**SECTION 00 91 13.01**  
**ADDENDA #01**

- A. Project Name: Royal C. Johnson Veterans Memorial Medical Center New Front Lobby & Primary Care Addition.
- B. Owner: U.S. Department of Veterans Affairs.
- C. Owner Project Number: 438-480
- D. Architect: Stone Group Architects.
- E. Architect Project Number: 201909.
- F. Date of Addendum: February 13, 2024.

Drawing Number  
AE402

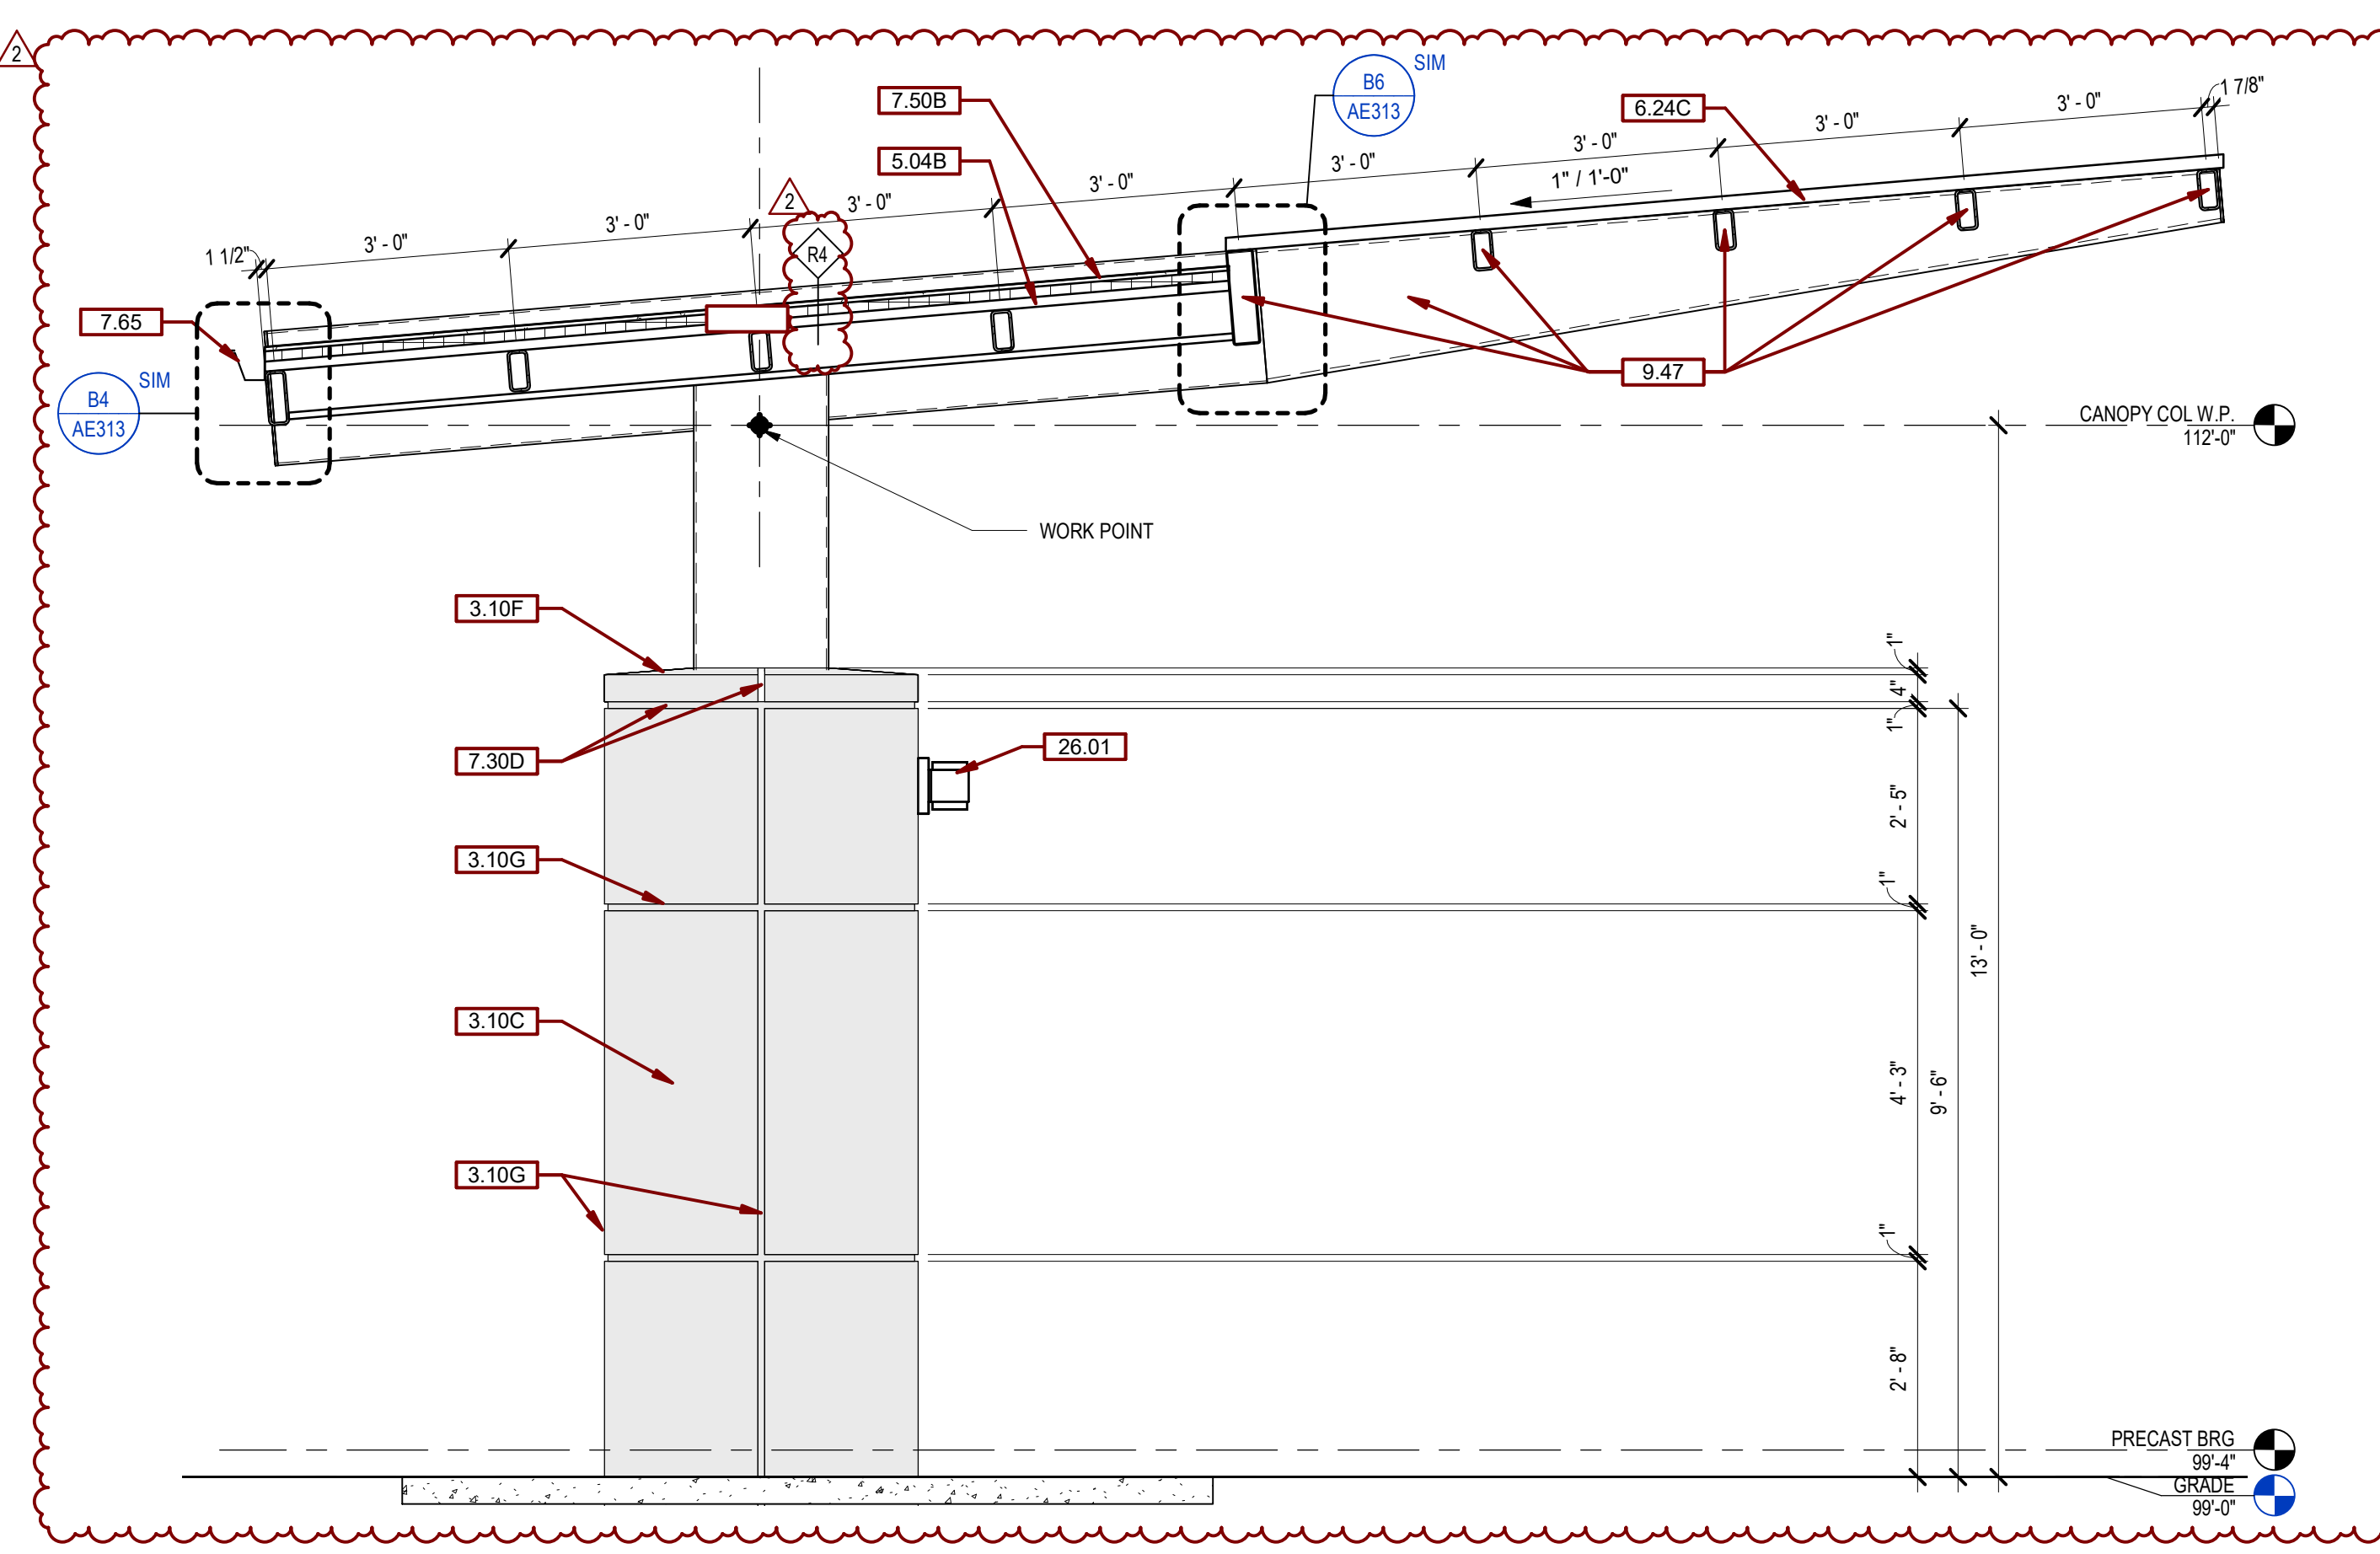
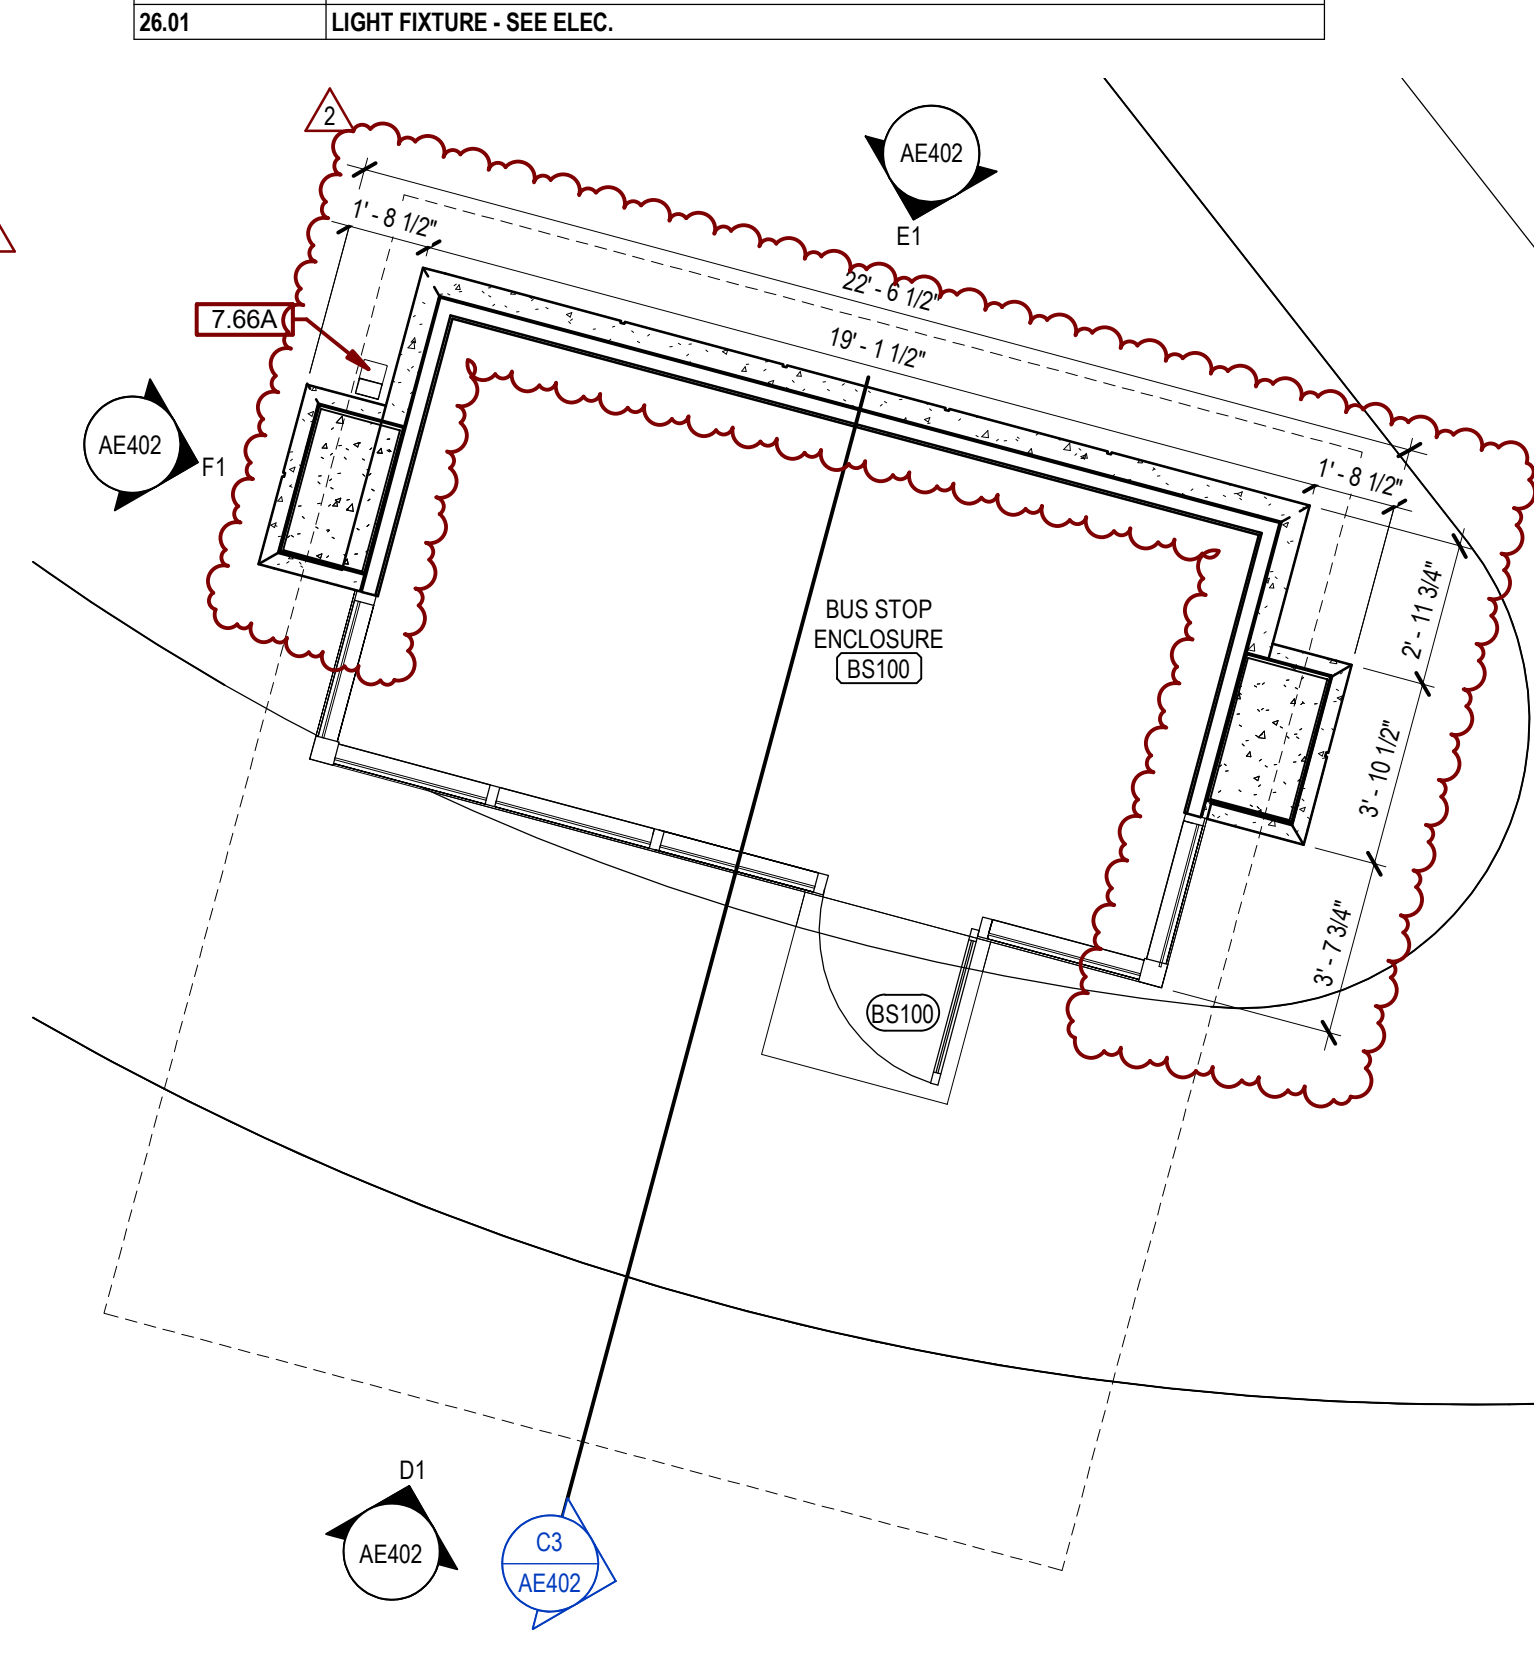
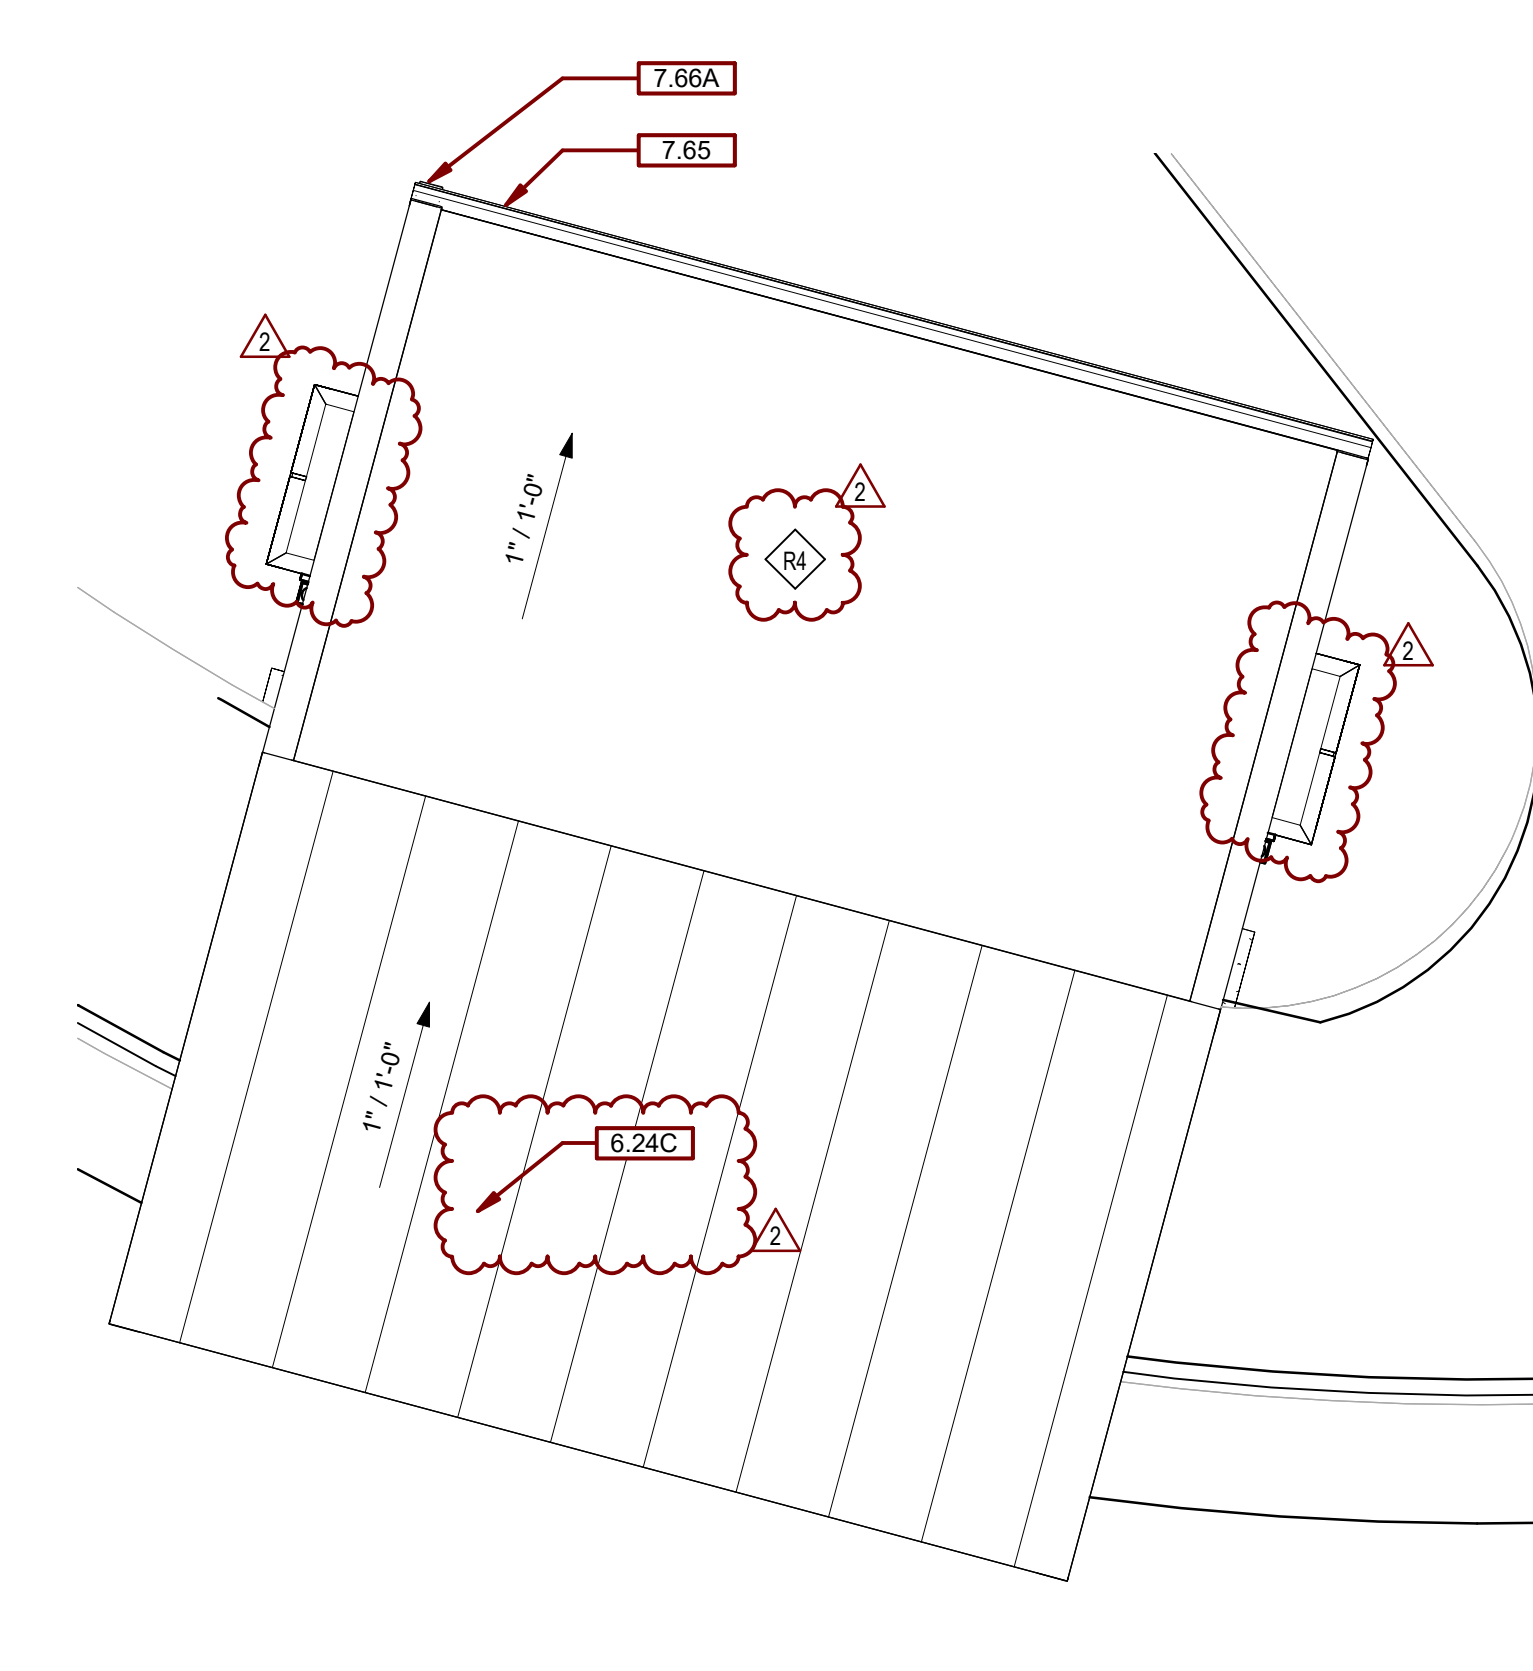
- Q. Sheet AE402 - BUS STOP DETAILS (reissued).
  - 1. Updates to detailing and clarifications for deduct alternate requirements.
